HISTORIC LANDMARK COMMISSION STAFF REPORT

200 Apartments- New Construction
Case PLNHLC2013-00239
and PLNHLC2013-00240
206 North 200 West
July 18, 2013

Applicant:
Matt Musgrave

ELEVATIONS - BUILDING B
NEW 200 APARTMENTS FOR MATT MUSGRAVE
206 NORTH 200 WEST
SALT LAKE CITY, UTAH 84103

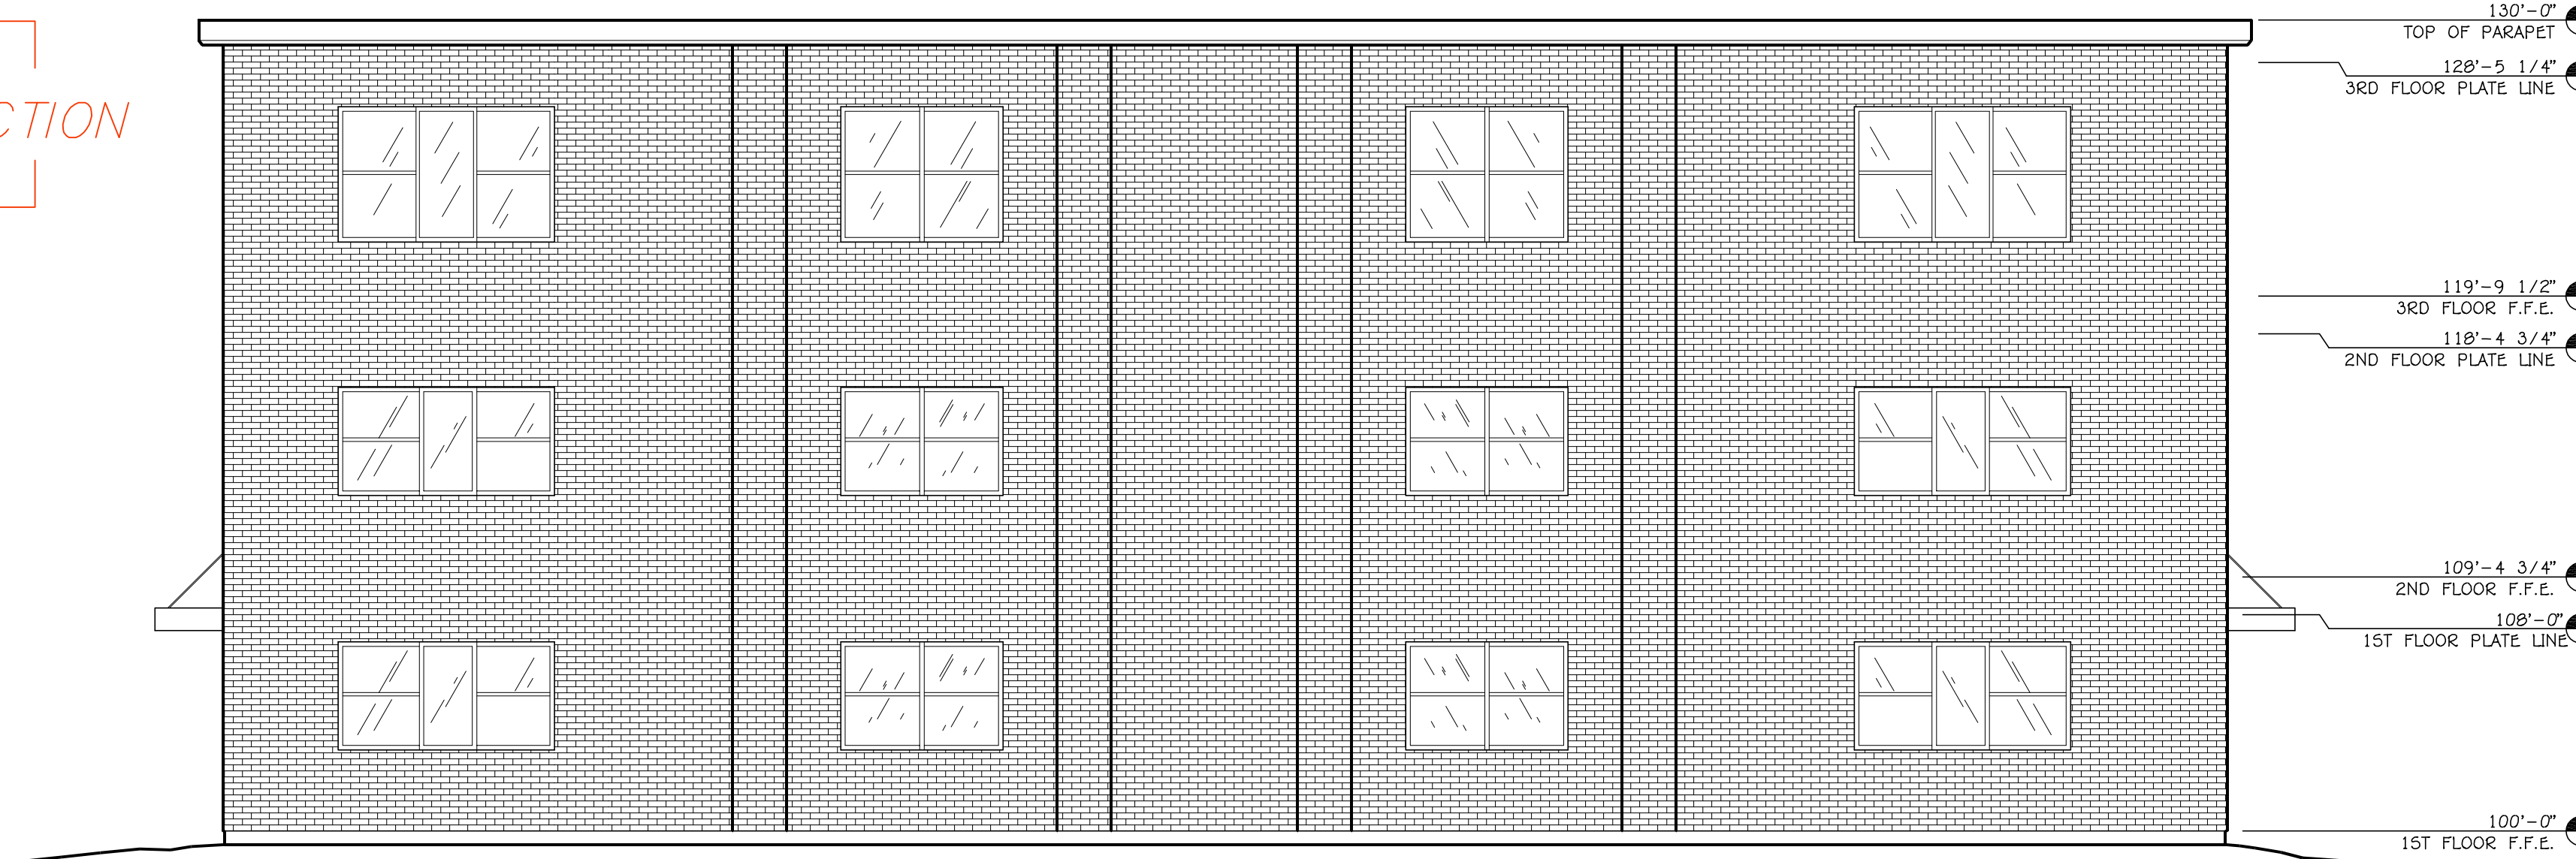
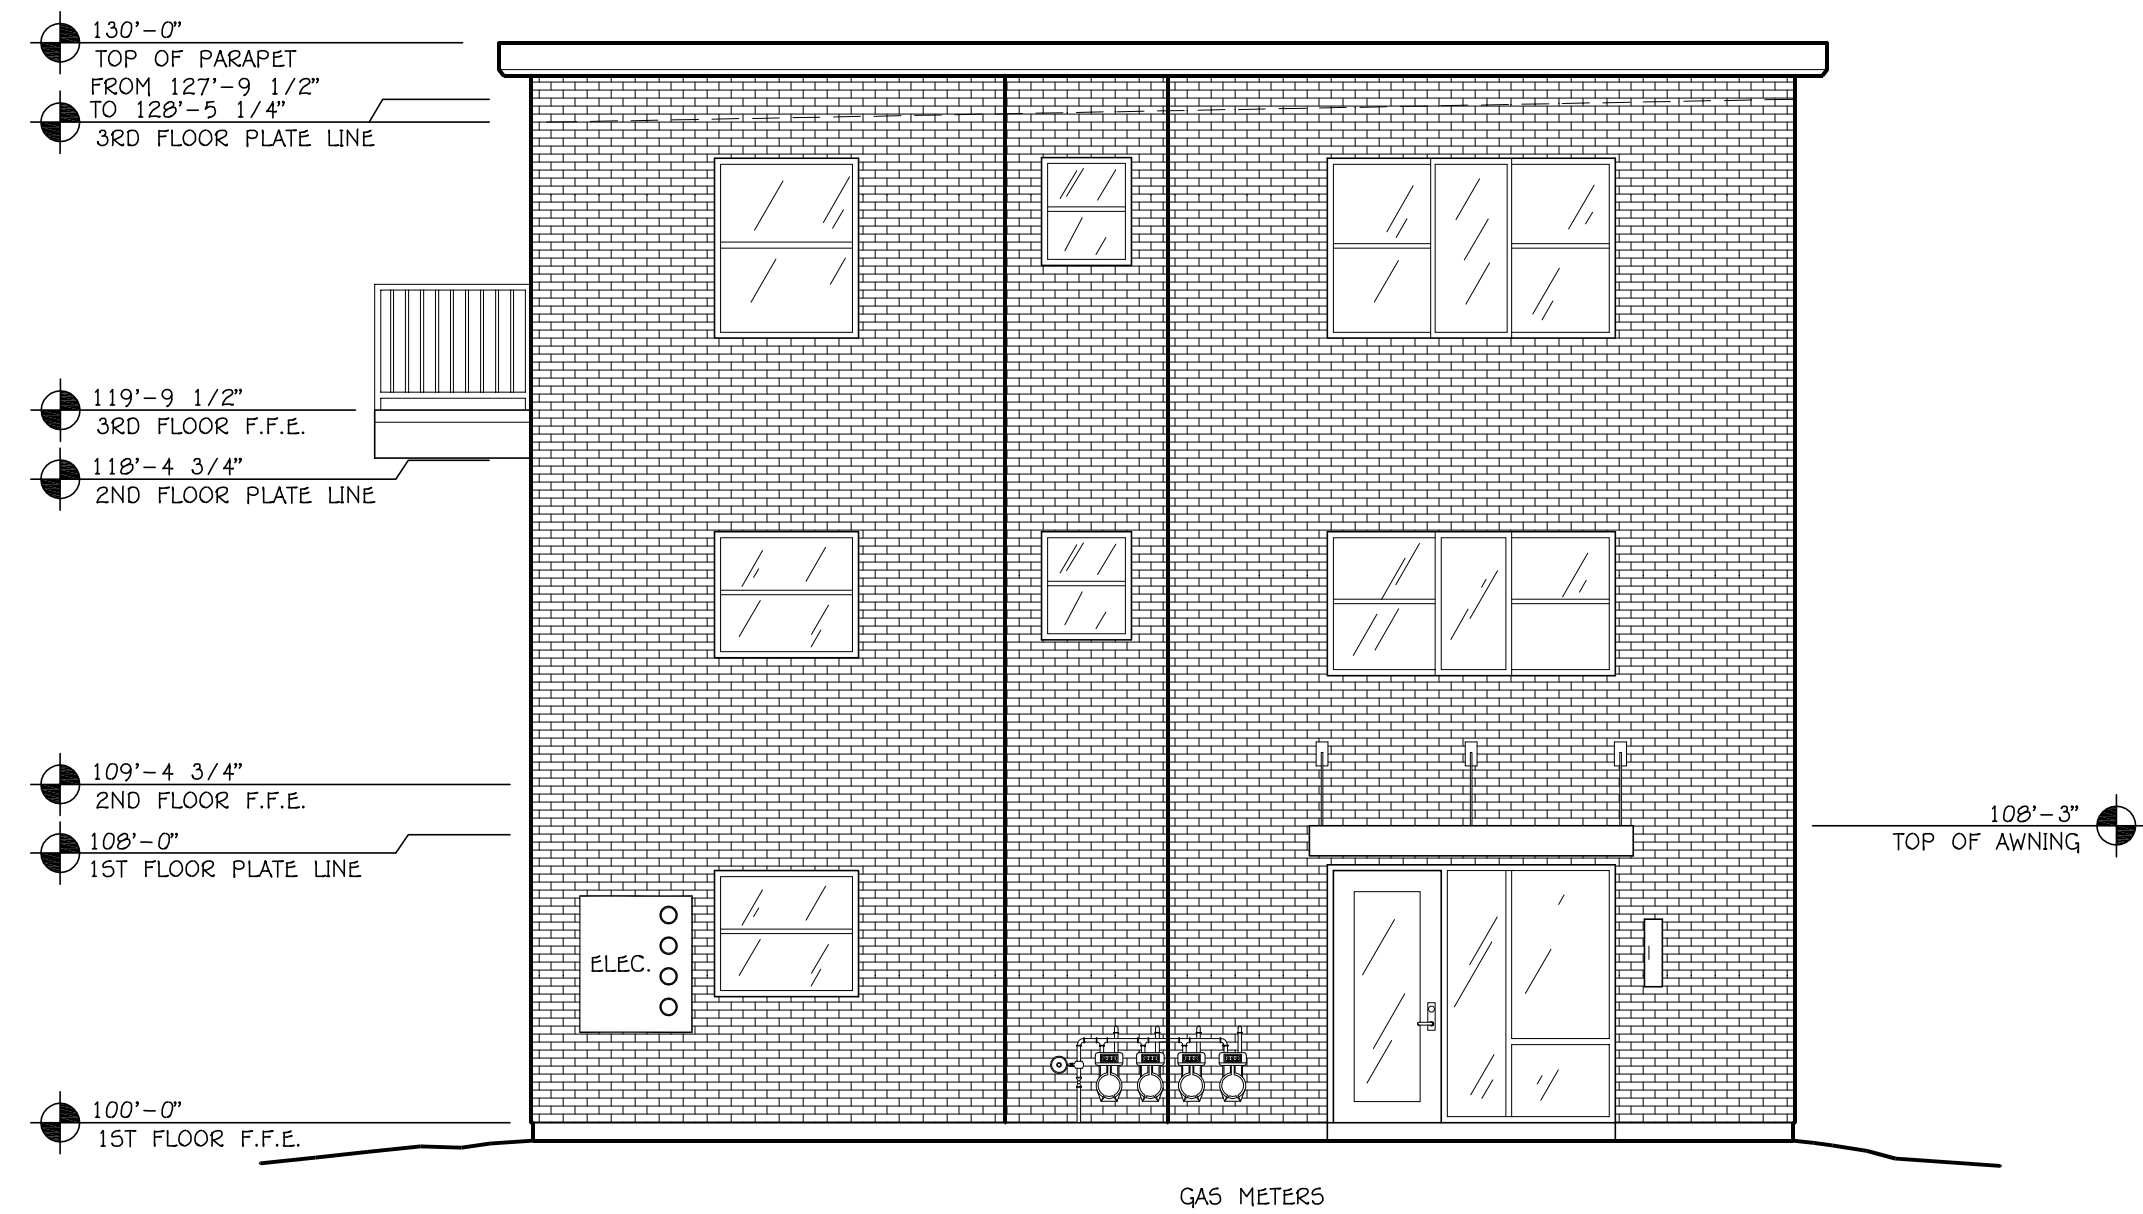
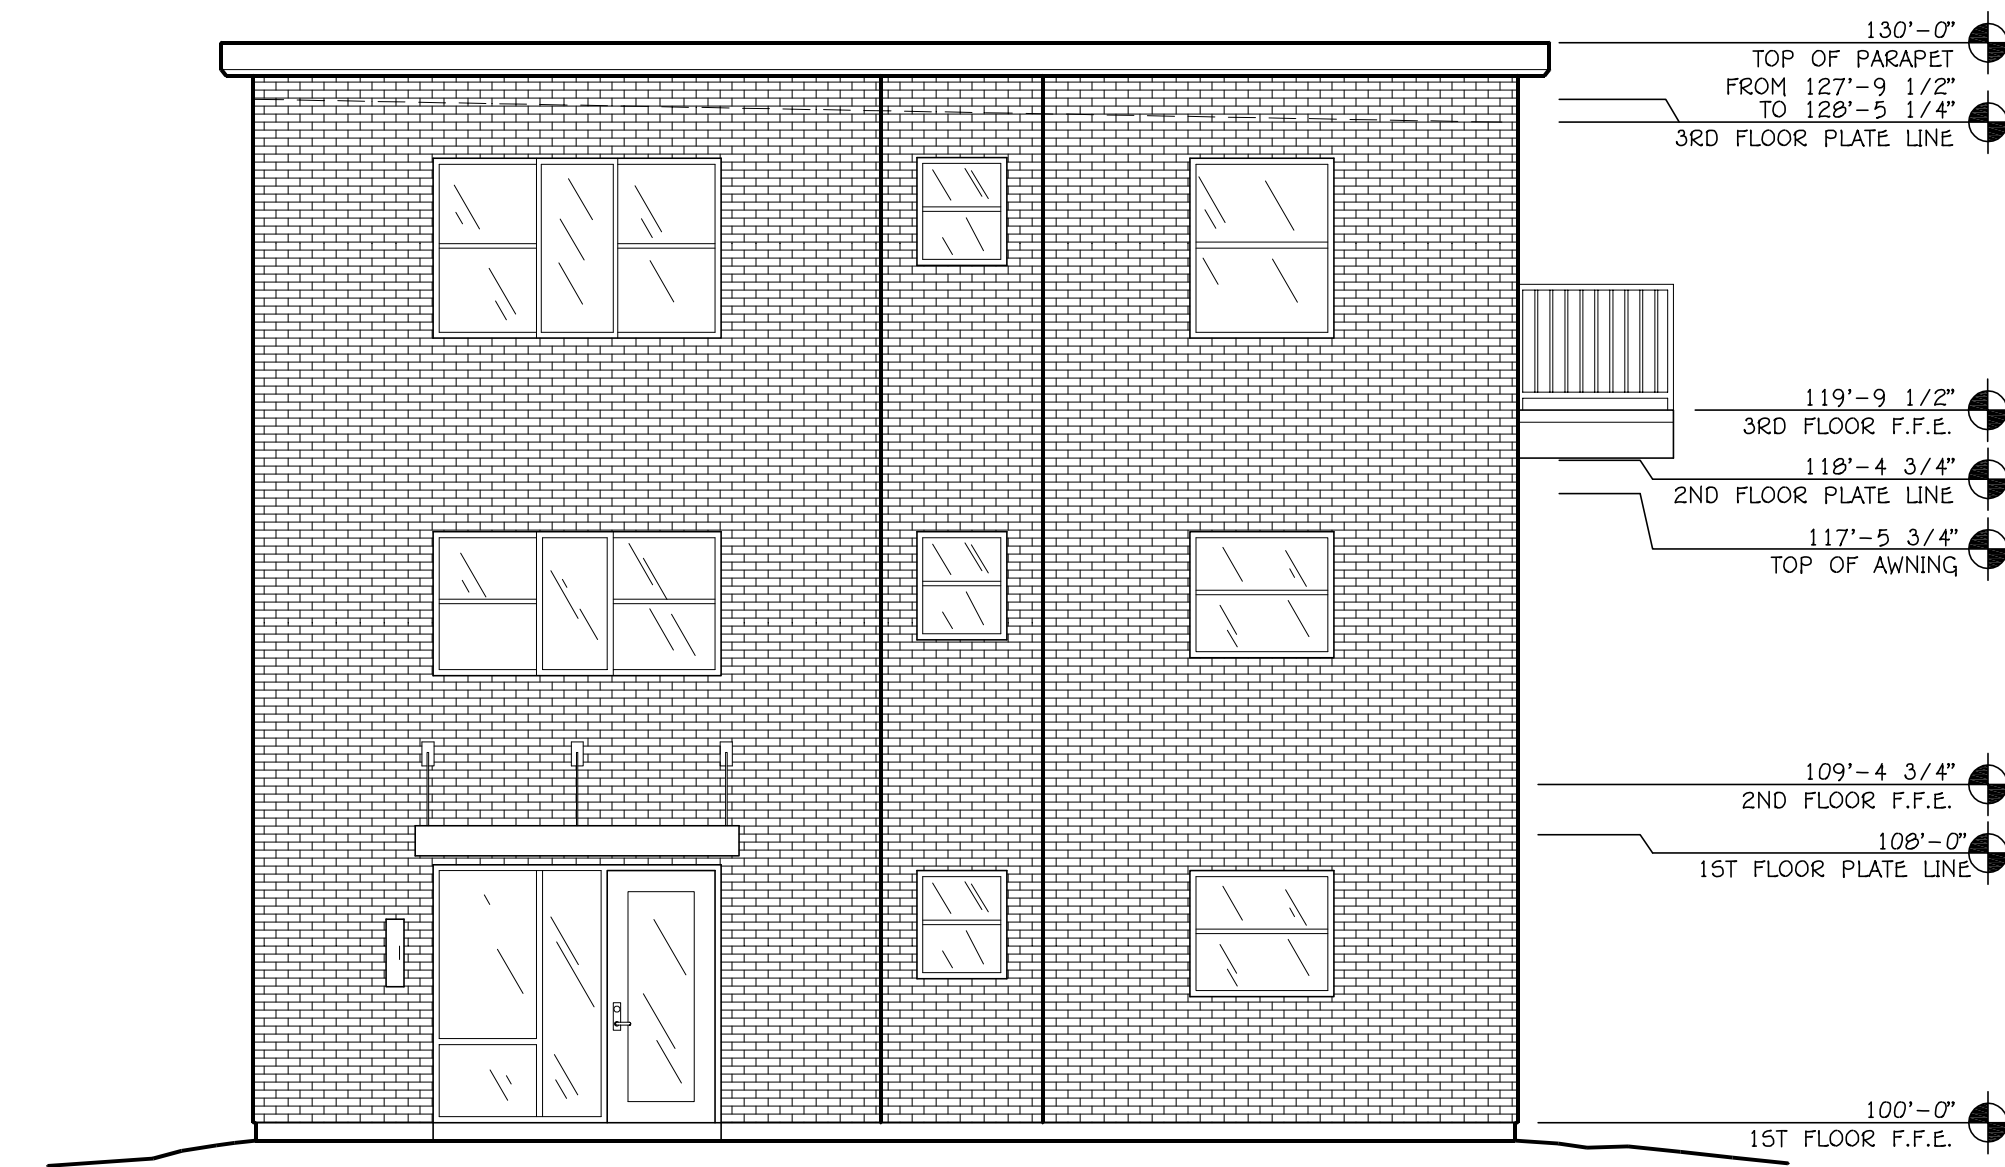
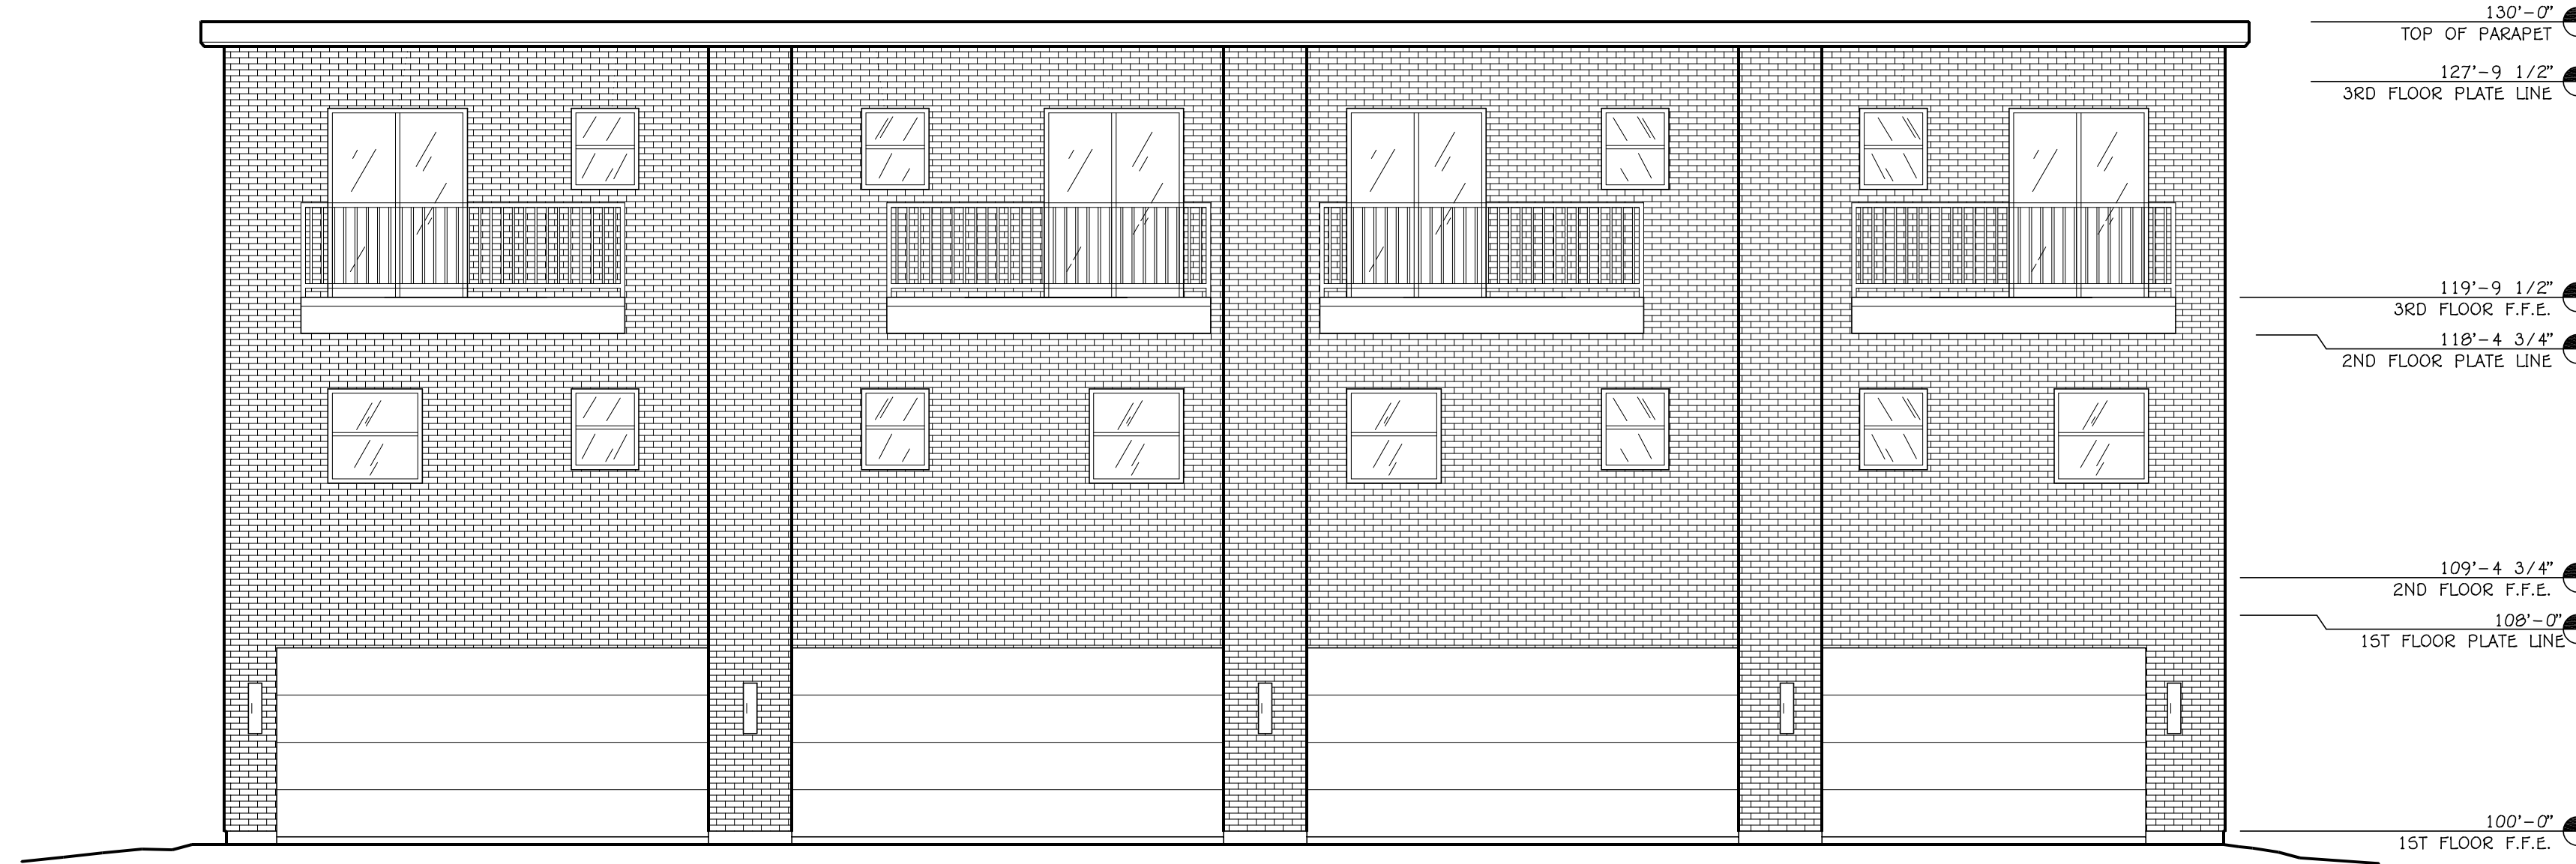
Analysis: The subcommittee requested that the petitioner make the windows less commercial in design, and that they be placed in a more uniform manner on the building. The applicant did so by standardizing the window styles and stacking them one above the other on each floor. Additionally, the design of the windows was changed from aluminum commercial style to a more residential style with double hung and casement type windows proposed. The proposed proportion of openings and rhythm of solids to voids is compatible with apartment buildings seen throughout the Capitol Hill Historic District.

The single family homes on the block face have front pedestrian entrances that are more prominent than the proposal, where as the apartment buildings have little to no entry features. The proposed buildings have the primary entrances facing 200 North and 200 West with a metal awning proposed over each entry. These entries are similar in style and design to other multi-family structures in the area. The relationship of materials in the proposal, primarily brick, will be visually compatible with other structures on the block face. The most prominent building material on the block is brick with various material types as accents.
